ADDENDUM #2

To: Prospective Bidders
From: Porter Co. Dept. of Development & Storm Water Management
Date: February 11, 2022
Subject: Kemper Ditch, Arm 15 – Drain Tile Reconstruction
Construction Services

4. Construction Plans

PROJECT:	KEMPER DITCH, ARM 15-DRAIN TILE RECONSTRUCTION
LOCATION:	1315 N 375 E
SHEET TITLE:	SHEET 2-PLAN STA. 0+00 TO STA. 7+00

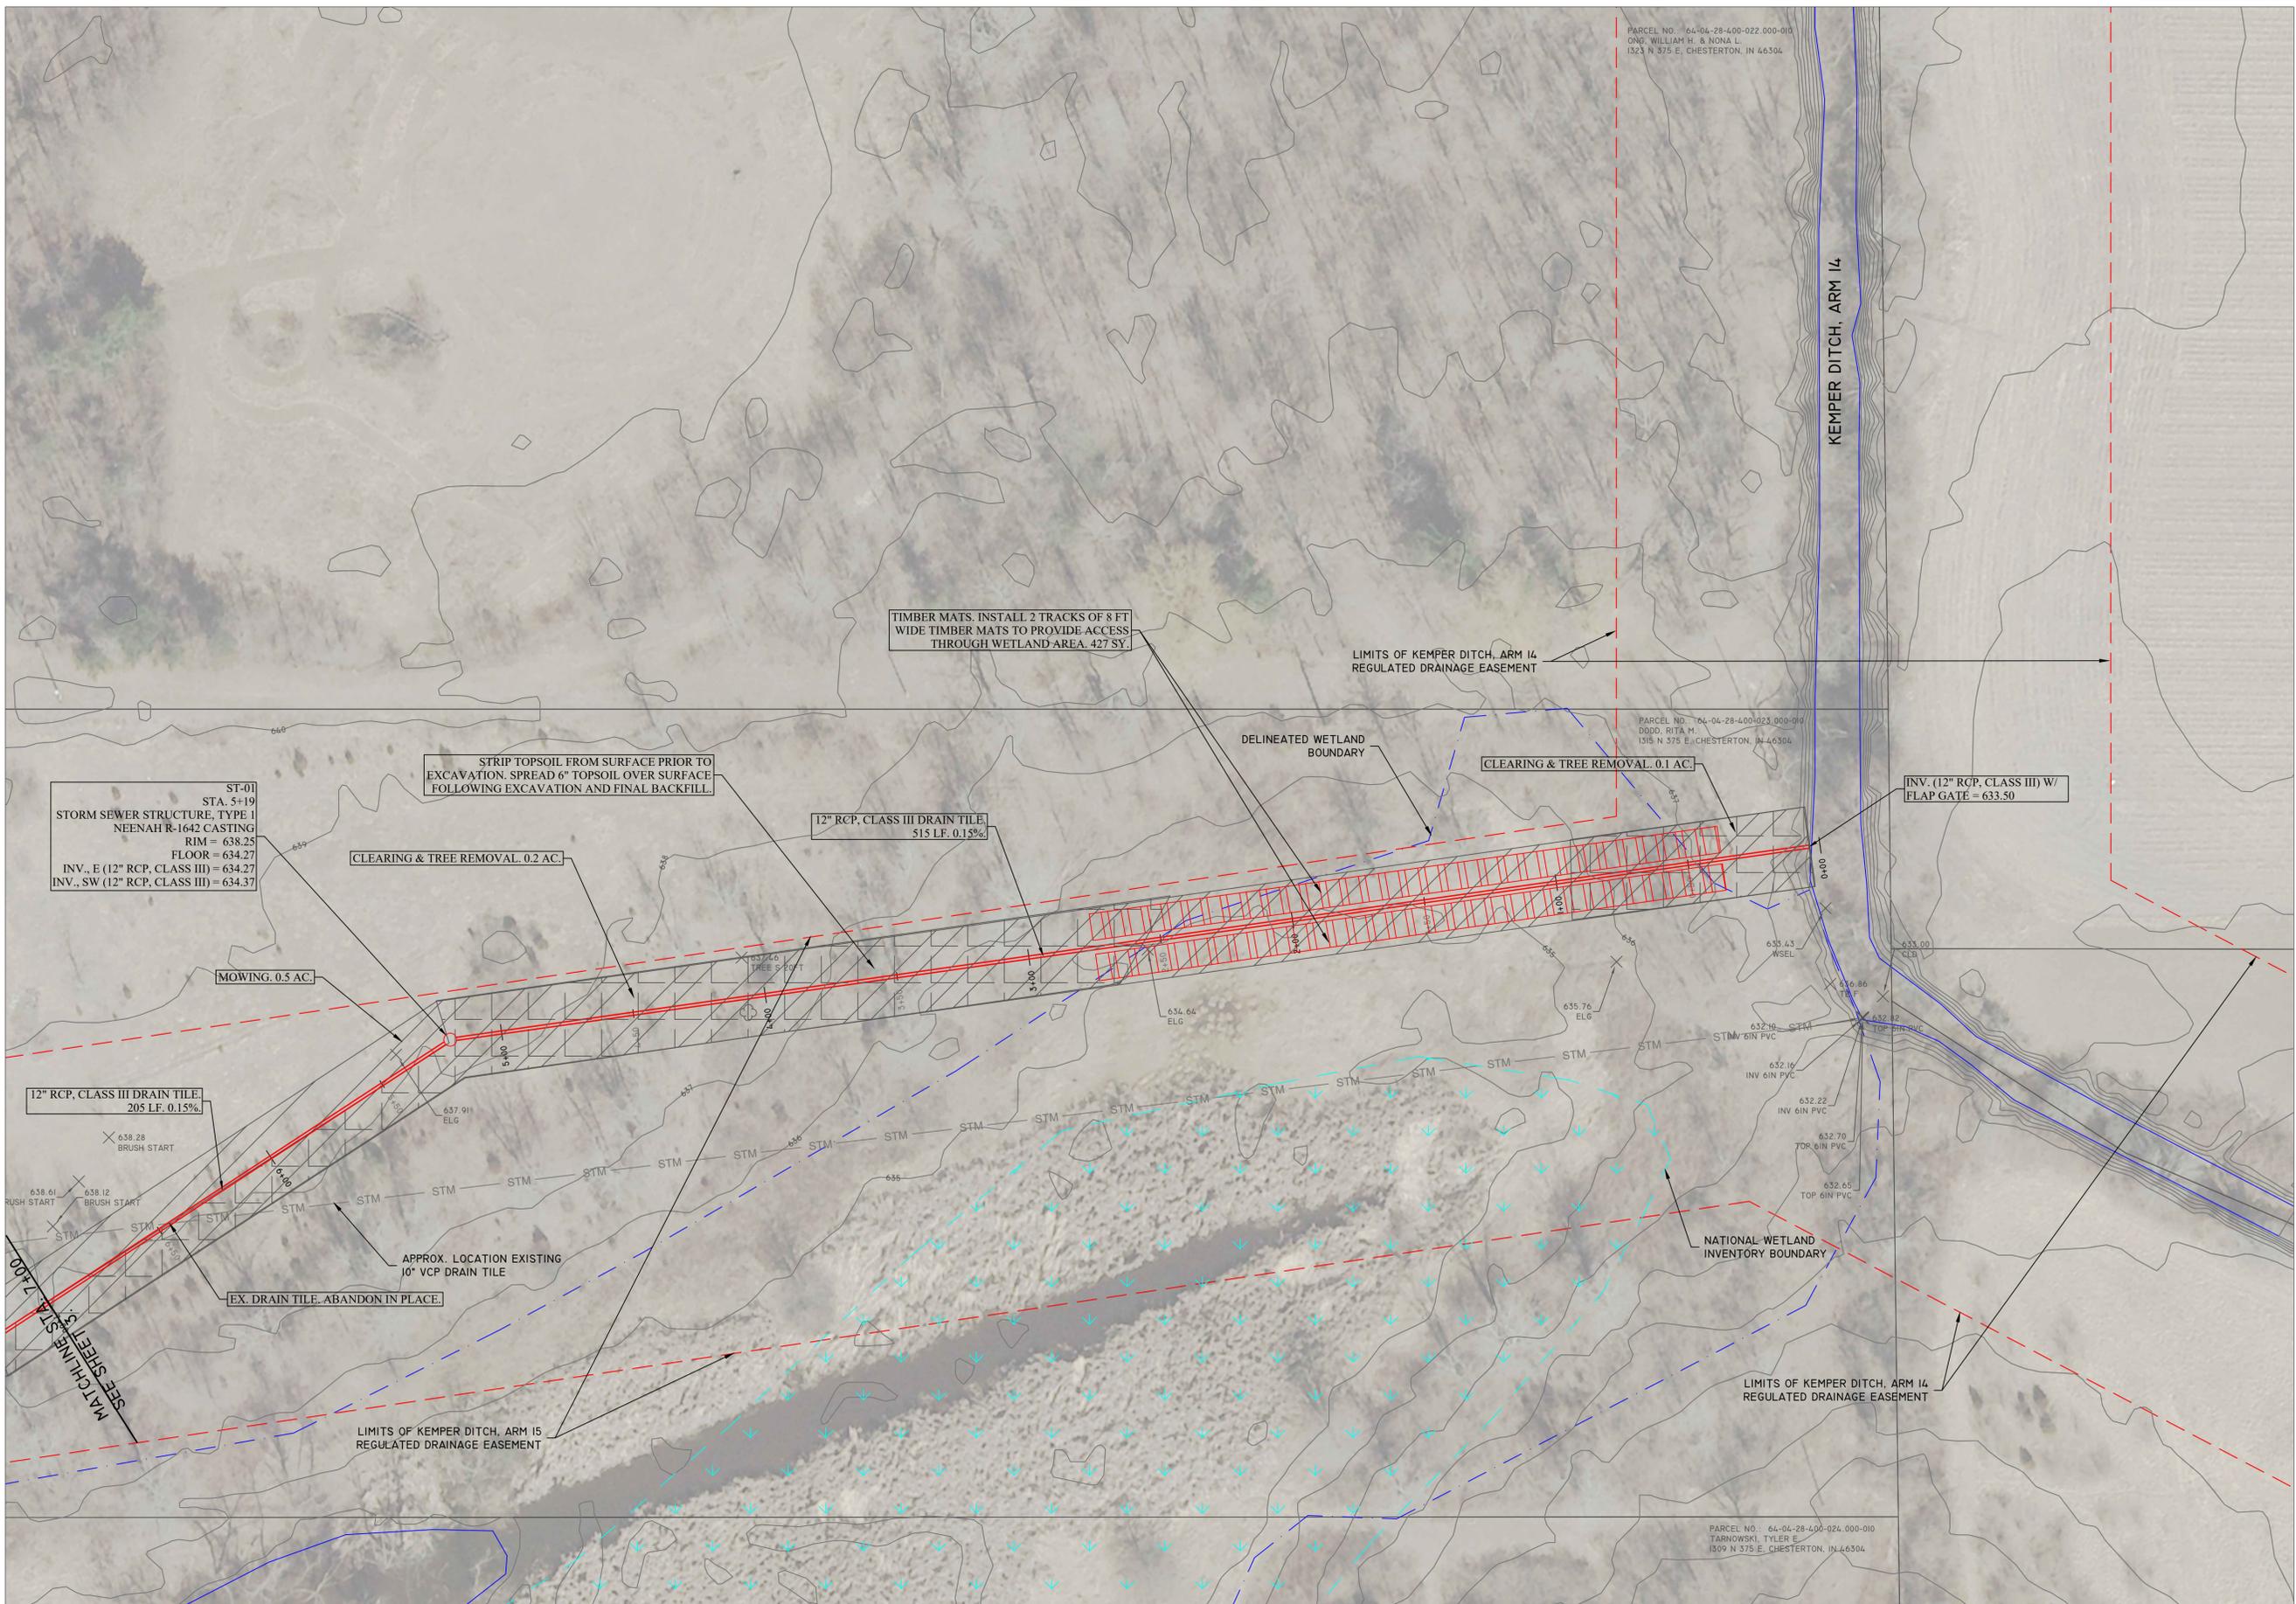
The construction plans have been revised to account for the location of the septic system serving the property commonly known as 1315 N 375 E, Chesterton, Indiana 46304. Changes in the scope, extent, and character of the project include a revised drain tile alignment, along with associated adjustments to quantities of the various items of work involved, in order to avoid such septic system.
